**Technical Service Bulletin (TSB)**  
**Electric Vehicle Control Unit (EVCU) Replacement**

| REFERENCE:         | TSB: 08-153-25 REV. A<br>GROUP: 08 - Electrical

**Fig. 1**  
EVCU Part Labels

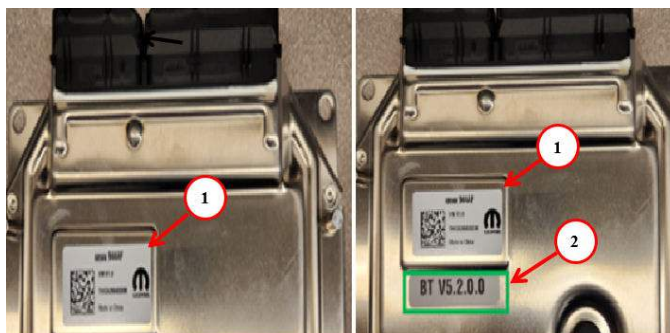
1. \*\*Is the vehicle on the RSU VIN list?
  - YES>> Proceed to [Step 2](#).
  - NO>>> Proceed to [Step 2](#).
2. Remove the storage bin. Refer to the detailed service procedures available in DealerCONNECT/Service Library under: Service Info> 23 - Body / Exterior / Bin, Storage / Removal.
3. Locate and inspect the EVCU part number label [Fig. 1](#).

4. Is the part number on the label 68566944AF and no other label stating BT V5.2.0.0 or BT V5.4.0.0 is found on the EVCU [Fig. 1](#)?
  - YES>>> Proceed to [Step 6](#).
  - NO>>> Proceed to [Step 5](#). Use Inspection LOP (08-19-49-9D) to close the active RSU.
5. Install the storage bin. Refer to the detailed service procedures available in DealerCONNECT/Service Library under: Service Info> 23 - Body / Exterior / Bin, Storage / Installation.\*\*
6. Replace the EVCU. Refer to the detailed service procedures available in DealerCONNECT/Service Library under: Service Info> 12 - Electrified Powertrain System / Electric Powertrain Control / Modules, High Voltage System / Removal and Installation.
7. \*\*Clear DTCs.\*\*

1 - EVCU Part Number Label with 68566944AF - Replace EVCU

2 - EVCU Part Number Label with 68566944AF and Additional EVCU Label (BT V5.2.0.0 or V5.4.0.0 Label) - Do Not Replace EVCU
